Recall Bulletin

SB-10056213-2868

PRODUCT EMISSION RECALL

SUBJECT: Oxygen Sensor Fracture

First and Second Design Sensors

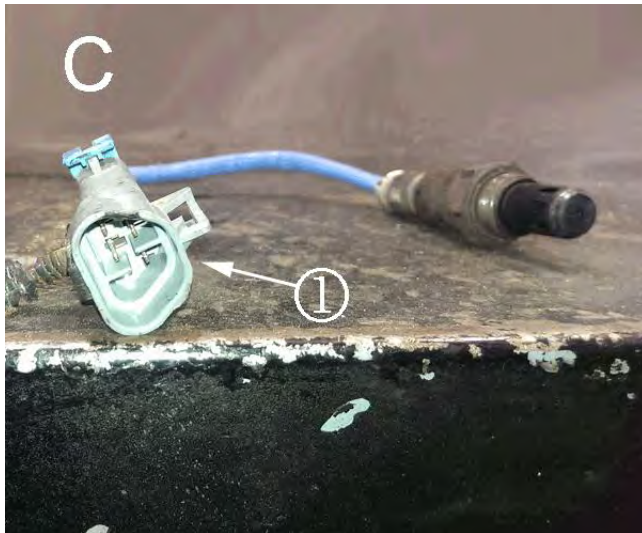
(A) 2011 through early 2013 OE production first design male connector. Replace the part with a second design part with a male connector, P/N 12637297. (B) 2011 through 2013 second design service part, P/N 12637297. Do NOT replace this part unless the part has failed. If the part has failed, replace the part with the second design part with a male connector, P/N 12637297.

(C) This is the second design 2013 production sensor with the female plug (1). The sensor and plug change was made to indicate the new design. Do NOT replace this sensor, P/N12656071, unless the part has failed.

3. Determine if a first design (A) or second design (B) heated oxygen sensor is installed using a light and mirror.
 - If a second design (B), P/N 12637297, P/N 12656071 heated oxygen sensor is currently installed, no further action is required. Lower the vehicle. Refer to *Lifting and Jacking the Vehicle* in SI.
 - If a first design (A), P/N 12612571, heated oxygen sensor is in place, remove the sensor and replace it with a second design heated oxygen sensor. Refer to *Heated Oxygen Sensor Replacement –Bank 2 Sensor 2* in SI and *Heated Oxygen Sensor Replacement –Bank 1 Sensor 2* in SI.
4. After installing the new heated oxygen sensors, reprogram the ECM. Refer to *Engine Control Module Programming* in this bulletin.
